**SUBJECT:** Transmittal of Revised Responses to AP1000 DSER Open Items

AP1000 Design Certification Review  
Draft Safety Evaluation Report Open Item Non-Proprietary Responses

DSER Open Item Number: 2.3.4-1 Revision 2

DSER Open Item Number: 3.8.4.5-2 (Response Revision 2)

Figure 15A-1

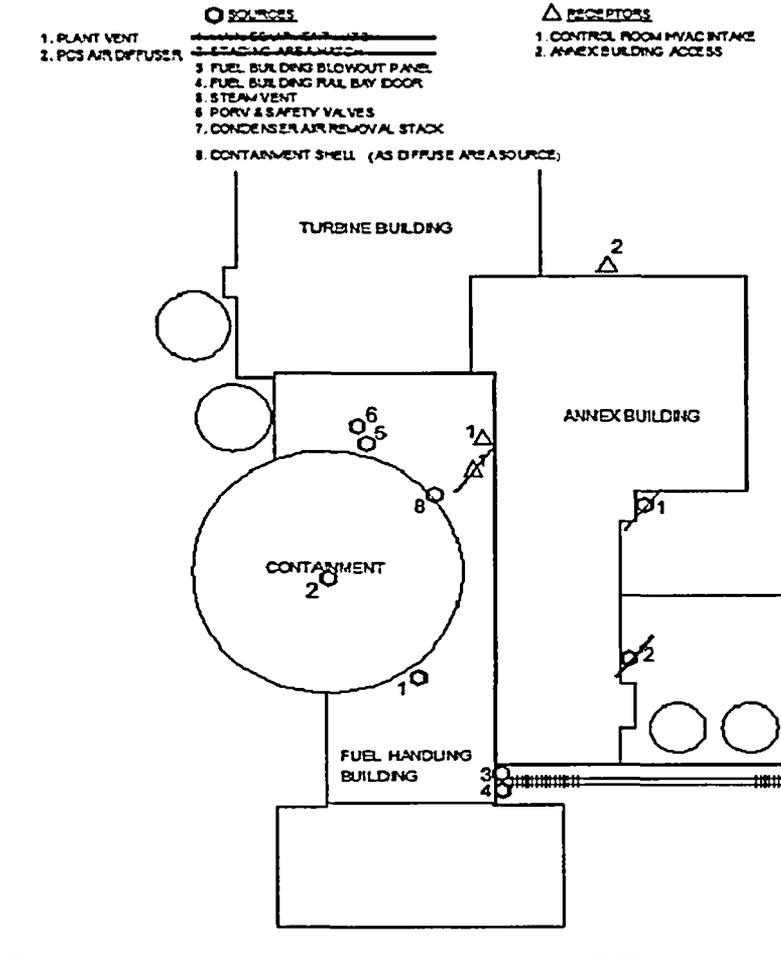
Westinghouse submitted revisions to address this question in DCD Revision 7. The staff had further questions in response to those revisions, particularly relating to the modeling used in the demonstration case control room  $\chi/Q$  values.

The ARCON96 modeling approach used (as illustrated in attached DCD mark-up, Table 15.A-7 and Figure 15A-1) is fully in compliance with Regulatory Guide 1.194.

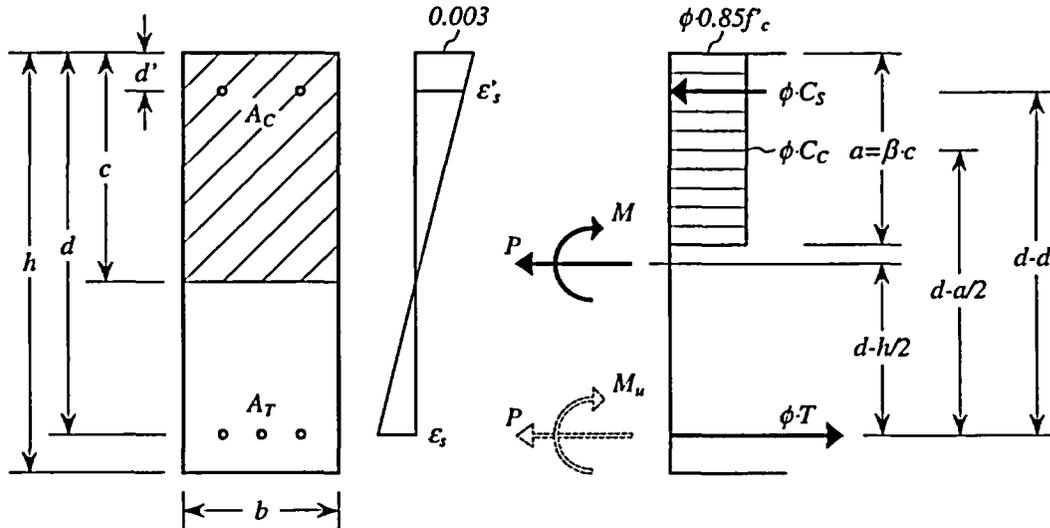
During the course of its review of the Wall 7.3 design calculation, the staff noted that the applicant had previously identified and corrected an error in the equation used by INITEC to calculate the required positive reinforcement for a section subjected to both bending moment and axial load. The staff could not conclude during the audit that the corrected equation accurately calculates required positive reinforcement. Therefore, the applicant was requested to submit the derivation of the equation currently used to calculate the required reinforcement. The applicant was also requested to submit a sample verification calculation for the computer algorithm, and verify that the corrected equation has been utilized in all calculations. This is Open Item 3.8.4.5-2.

The development of the equation for sizing the required reinforcement for a section subject to bending moment and axial load is shown in this response. This equation is applicable when the strength of the section is controlled by yielding of the tension steel and both tension and compression steel, if any, are at yield. Loads and internal forces are shown in the following figures. The design loads  $P$  and  $M$  act at the centroid of the section, where:

Figure 3.8.4.5-2-1  
Axial Load-Moment Interaction Diagram

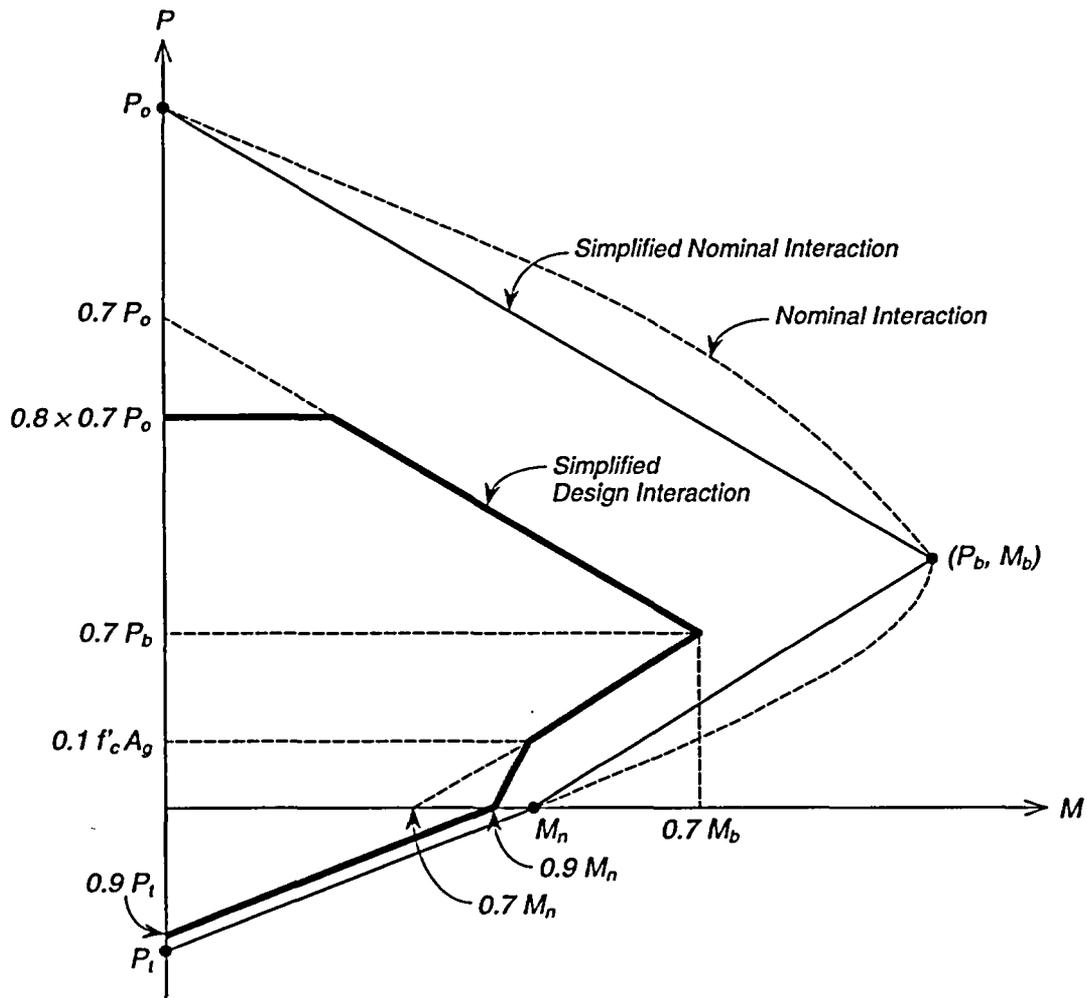
The Revision 0 response only showed development of equation for one case (axial plus bending with both tension and compression steel at yield). Clarify how range of applicability is checked and what other cases are used in the macro or explain how design engineer is told that the case is out of range of applicability.

Figure 3.8.4.5-2-1 shows a typical interaction diagram defining the strength of a concrete section under combined axial force ( $P$ ) and bending moment ( $M$ ). It shows the nominal strength interaction as well as a simplified nominal interaction based on straight lines connecting the following key points:

Guidance is being provided to the engineer to perform an additional check when the axial compressive forces are greater than  $\phi P_b$ . In this additional check the axial load-moment interaction diagram is calculated for the reinforcement that has been selected based on use of the macro. Combinations of design moments with axial forces greater than  $\phi P_b$  are reviewed and confirmed to be bounded by the interaction diagram.
